Amendment-VII dated 18.04.2024 on the RFP Documents for Selection of Bidder as Transmission Service Provider Through Tariff Based Competitive Bidding Process to establish Inter-State Transmission System for “Transmission System for Evacuation of power from potential renewable energy zone in Khavda area of Gujarat under Phase-IV (7 GW): Part C” through tariff based competitive bidding process.

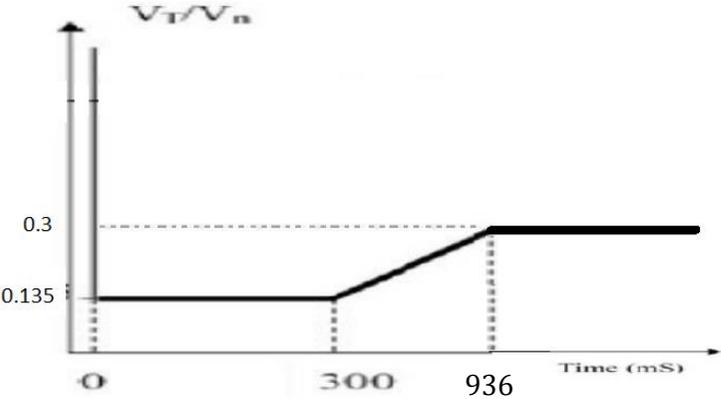
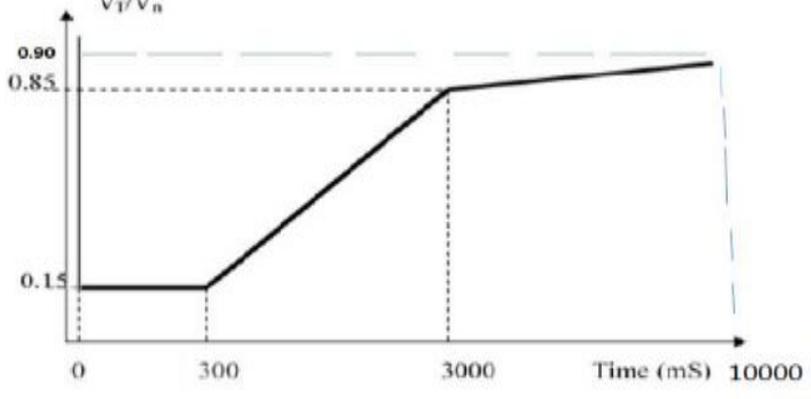
4	<p>RFP</p> <p>Specific Technical Requirements for STATCOM</p> <p>Clause no. C.3</p>	<p>C.3 Scope of work for STATCOM</p> <p>.....</p> <p>.....</p> <p>TSP shall carry out a detailed study on prevailing system conditions before interconnection of the STATCOM to assess the performance of the STATCOM. Parameters tuning to avoid any adverse impact on the grid with integration of the</p>	<p>C.3 Scope of work for STATCOM</p> <p>.....</p> <p>.....</p> <p>TSP shall carry out a detailed study on prevailing system conditions before interconnection of the STATCOM to assess the performance of the STATCOM. Parameters tuning to avoid any adverse impact on the grid with integration of the STATCOM shall also be identified and</p>

Sl. No.	Clause No.	Existing Clause	New/Revised Clause
		<p>STATCOM shall also be identified and implemented at this stage. TSP shall carry out tuning of Power Oscillation damping (POD) along with an interaction study with nearby HVDC/FACTS controllers.</p> <p>.....</p> <p>.....</p>	<p>implemented at this stage. TSP shall carry out tuning of Power Oscillation damping (POD) along with an interaction study with nearby HVDC/FACTS controllers.</p> <p><u>TSP shall ensure interconnection study at the time of commissioning and shall also be responsible for tuning the POD during the license period as per relevant standards (e.g. IEEE 1052).</u></p> <p>.....</p> <p>.....</p>
5	RFP Specific Technical Requirements for STATCOM Clause no. C.8.4	<p>C.8.4 STATCOM Station Fault Recording System</p> <p>An integrated Transient Fault Recording (TFR) System shall be supplied, installed and commissioned. This shall include trigger level settings for analog signal, etc subject to review and comment. Disturbance and event recording facilities are required for local monitoring of the STATCOM following a disturbance on the power system or the STATCOM System. The following inputs are required:</p> <ul style="list-style-type: none"> • All analog signals (output signals) including 3-ph & sequence values of voltage, current. • All digital signals (control outputs, status indications, commands, alarms, and trip indications). Internal STATCOM Station control signals/variables to be selectable. • The accuracy of the TFR for event inputs shall be at least 100 μs (sampling rate of minimum 10 kHz). 	<p>C.8.4 STATCOM Station Fault Recording System</p> <p>An integrated Transient Fault Recording (TFR) System shall be supplied, installed and commissioned. This shall include trigger level settings for analog signal, etc subject to review and comment. Disturbance and event recording facilities are required for local monitoring of the STATCOM following a disturbance on the power system or the STATCOM System. The TFR shall be GPS synchronized.</p> <p>The following inputs are required:</p> <ul style="list-style-type: none"> • All analog signals (output signals) including 3-ph and sequence values of voltage, current. • All digital signals (control outputs, status indications, commands, alarms, and trip indications). Internal STATCOM Station control signals/variables to be selectable. • The accuracy of the TFR for event inputs shall be at least 100 μs (sampling rate of minimum 10 kHz).

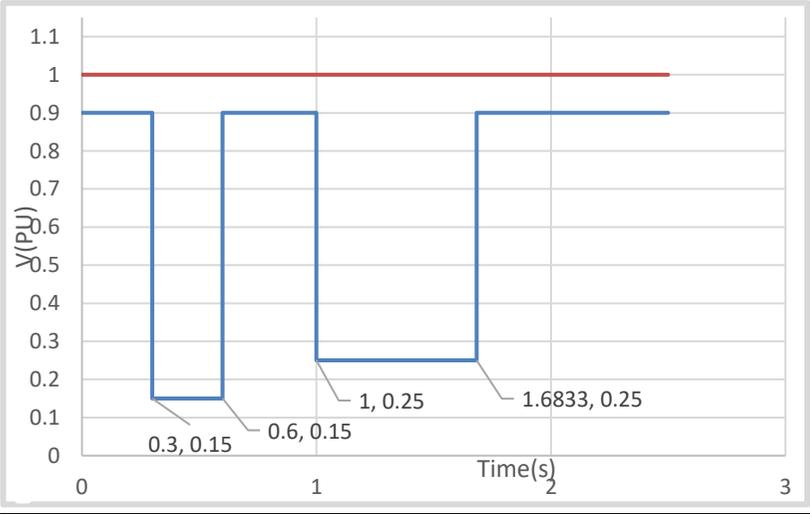
9	C.6.1 STATCOM Station Ratings	<p>.....</p> <p>.....</p> <p>e) The STATCOM <u>should</u> continue to absorb reactive power during <u>temporary over voltages</u> in a controlled manner as per the following.</p> <table border="1" data-bbox="504 1252 1102 1420"> <thead> <tr> <th><u>Temporary Overvoltage</u></th> <th><u>Duration</u></th> </tr> </thead> <tbody> <tr> <td><u>up to 600 kV (1.5 pu)</u></td> <td><u>10 seconds</u></td> </tr> <tr> <td><u>up to 704 kV (1.76 pu)</u></td> <td><u>100 milli sec</u></td> </tr> <tr> <td><u>up to 800 kV (2.0 pu)</u></td> <td><u>50 milli sec</u></td> </tr> </tbody> </table>	<u>Temporary Overvoltage</u>	<u>Duration</u>	<u>up to 600 kV (1.5 pu)</u>	<u>10 seconds</u>	<u>up to 704 kV (1.76 pu)</u>	<u>100 milli sec</u>	<u>up to 800 kV (2.0 pu)</u>	<u>50 milli sec</u>	<p>.....</p> <p>.....</p> <p>e) The STATCOM <u>shall</u> continue to absorb reactive power during <u>HVRT Conditions</u> in a controlled manner as per the following.</p> <table border="1" data-bbox="1301 1214 2092 1417"> <thead> <tr> <th><u>Nominal Voltage (pu)</u></th> <th><u>Minimum time for remaining connected to the Grid</u></th> </tr> </thead> <tbody> <tr> <td><u>V > 1.50</u></td> <td><u>Instantaneous trip</u></td> </tr> <tr> <td><u>1.50 ≥ V > 1.30</u></td> <td><u>100 milli seconds</u></td> </tr> <tr> <td><u>1.30 ≥ V > 1.10</u></td> <td><u>10 seconds</u></td> </tr> </tbody> </table>	<u>Nominal Voltage (pu)</u>	<u>Minimum time for remaining connected to the Grid</u>	<u>V > 1.50</u>	<u>Instantaneous trip</u>	<u>1.50 ≥ V > 1.30</u>	<u>100 milli seconds</u>	<u>1.30 ≥ V > 1.10</u>	<u>10 seconds</u>

<u>Temporary Overvoltage</u>	<u>Duration</u>																		
<u>up to 600 kV (1.5 pu)</u>	<u>10 seconds</u>																		
<u>up to 704 kV (1.76 pu)</u>	<u>100 milli sec</u>																		
<u>up to 800 kV (2.0 pu)</u>	<u>50 milli sec</u>																		
<u>Nominal Voltage (pu)</u>	<u>Minimum time for remaining connected to the Grid</u>																		
<u>V > 1.50</u>	<u>Instantaneous trip</u>																		
<u>1.50 ≥ V > 1.30</u>	<u>100 milli seconds</u>																		
<u>1.30 ≥ V > 1.10</u>	<u>10 seconds</u>

Sl. No.	Clause No.	Existing Clause	New/Revised Clause		
		<p>STATCOM Station may be tripped if the respective temporary over voltages as mentioned above persists for more than its respective mentioned duration.</p> <p>.....</p> <p>.....</p>	<table border="1" style="width: 100%; border-collapse: collapse;"> <tr> <td style="text-align: center; width: 50%;"><u>V ≤ 1.10</u></td> <td style="text-align: center; width: 50%;"><u>Continuous</u></td> </tr> </table> <p>STATCOM Station may be tripped if the respective temporary over voltages as mentioned above persists for more than its respective mentioned duration.</p> <p>.....</p> <p>.....</p>	<u>V ≤ 1.10</u>	<u>Continuous</u>
<u>V ≤ 1.10</u>	<u>Continuous</u>				
10	C.6.2.1 STATCOM Station Functions and Applications	<p>C.6.2.1.1 Voltage Control mode (Automatic and Manual)</p> <p>Control of the positive sequence component of the fundamental frequency voltage in steady state <u>and dynamic operation</u>, with slope in the range as specified at clause 6.1 c) above.</p>	<p>C.6.2.1.1 Voltage Control mode (Automatic and Manual)</p> <p>Control of the positive sequence component of the fundamental frequency voltage in steady state <u>at POI</u>, with slope in the range as specified at clause 6.1 c) above.</p> <p><u>There shall be following provisions in STATCOM System to operate in Voltage Control Mode:</u></p> <p><u>a) To adjust the reference voltage for changes by Grid operator.</u></p> <p><u>b) To adjust the value of reactive power droop in pu to provide a stable, coordinated and dynamic response.</u></p> <p><u>c) To adjust the voltage dead band with a minimum magnitude of ±0.05 pu</u></p>		
11	C.6.2.1 STATCOM	<p>C.6.2.1.2 Fixed Reactive Power Mode</p> <p><u>In this mode, the reactive power output of the</u></p>	<p>C.6.2.1.2 Fixed Reactive Power Mode</p> <p><u>In this mode, the STATCOM system shall maintain a specified</u></p>
